TEXAS UTILITIES ELECTRIC COMPANY
COMANCHE PEAK STEAM ELECTRIC STATION, UNIT 1
DOCKET NO. 50-445
AMENDMENT TO FACILITY OPERATING LICENSE

Amendment No. 49
License No. NPF-87

TEXAS UTILITIES ELECTRIC COMPANY
COMANCHE PEAK STEAM ELECTRIC STATION, UNIT 2
DOCKET NO. 50-446
AMENDMENT TO FACILITY OPERATING LICENSE

ATTACHMENT TO LICENSE AMENDMENT NOS. 49 AND 35
FACILITY OPERATING LICENSE NOS. NPF-87 AND NPF-89
DOCKET NOS. 50-445 AND 50-446

FIGURE 2.1-1b
UNIT 2 REACTOR CORE SAFETY LIMITS

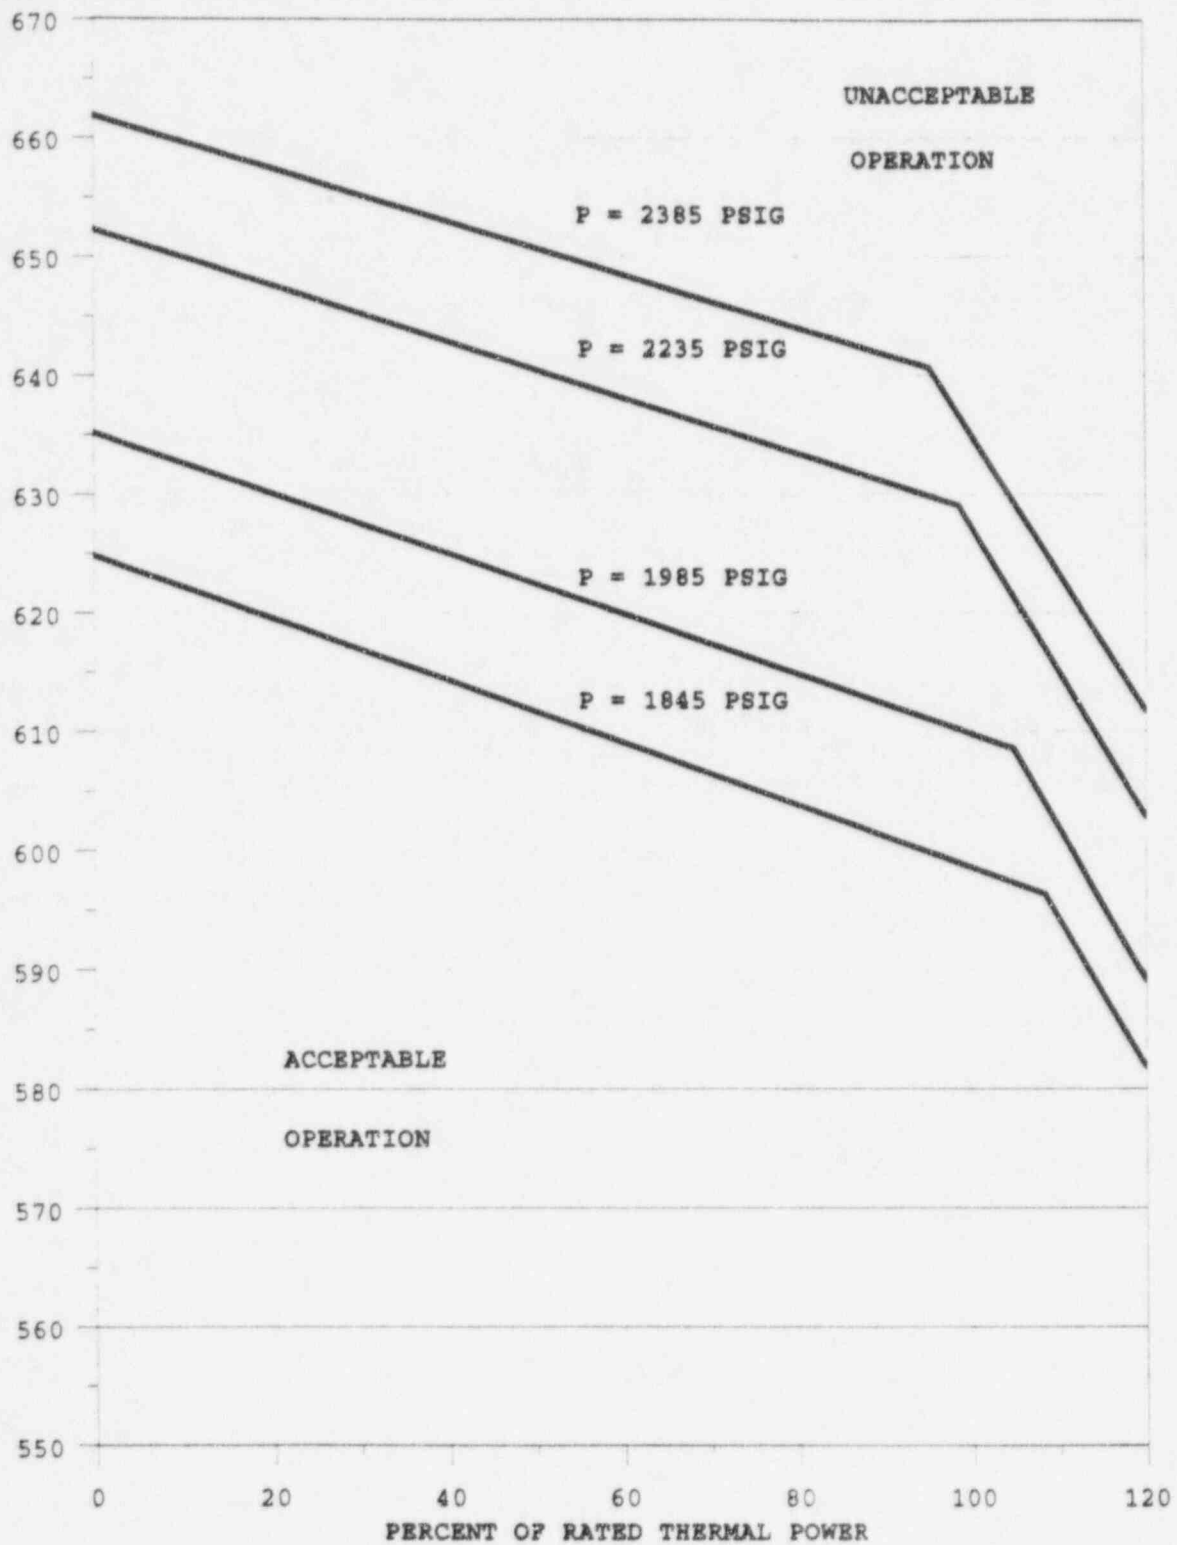
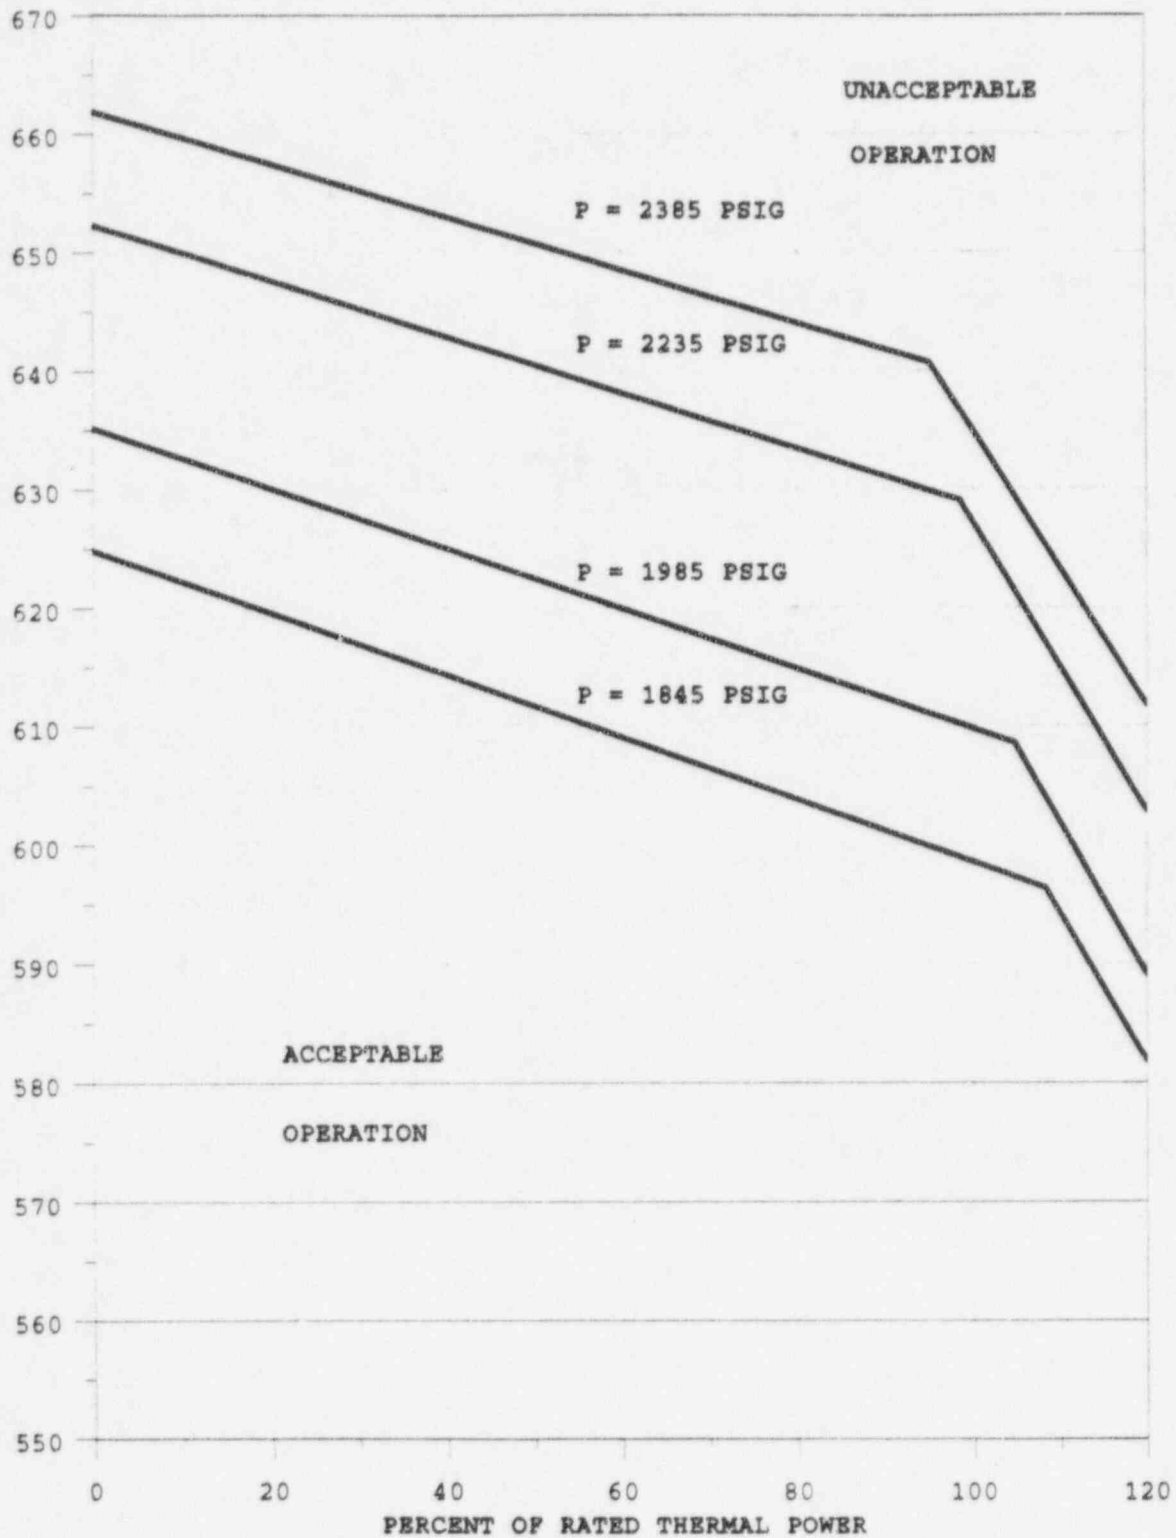
Replace the following pages of the Appendix A Technical Specifications with the attached pages. The revised pages are identified by Amendment number and contain marginal lines indicating the areas of change. The corresponding overleaf pages are also provided to maintain document completeness.
